# Access Compliance Report Public Rights-of-Way (Curb Ramps)

Main Street: CREIGHTON\_DR Cross Street: CREIGHTON\_DR Location: NW

ADA ID: RPRK211026141541 Ramp Type: Type 1 - Perpendicular Initial Pass/Fail: Fail Overall Compliance: No Severity Score: 16

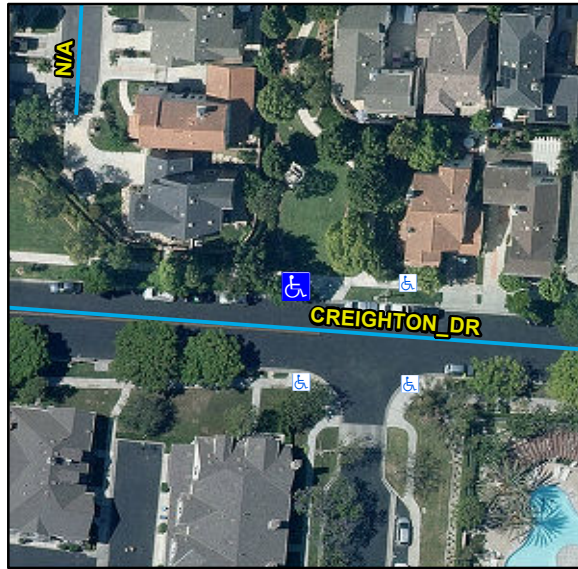
| Compliance | Description                           | Data | Compliance | Description                   | Data |
|------------|---------------------------------------|------|------------|-------------------------------|------|
| No         | Ramp Run Slope (%)                    | 11.2 | N/A        | Flare Slope LT (%)            | N/A  |
| N/A        | Gutter Ponding                        | N/A  | No         | Curb Slope                    | 10.1 |

Remove & Replace Entire Ramp.

R304.2.2, R204.3, STD 1115
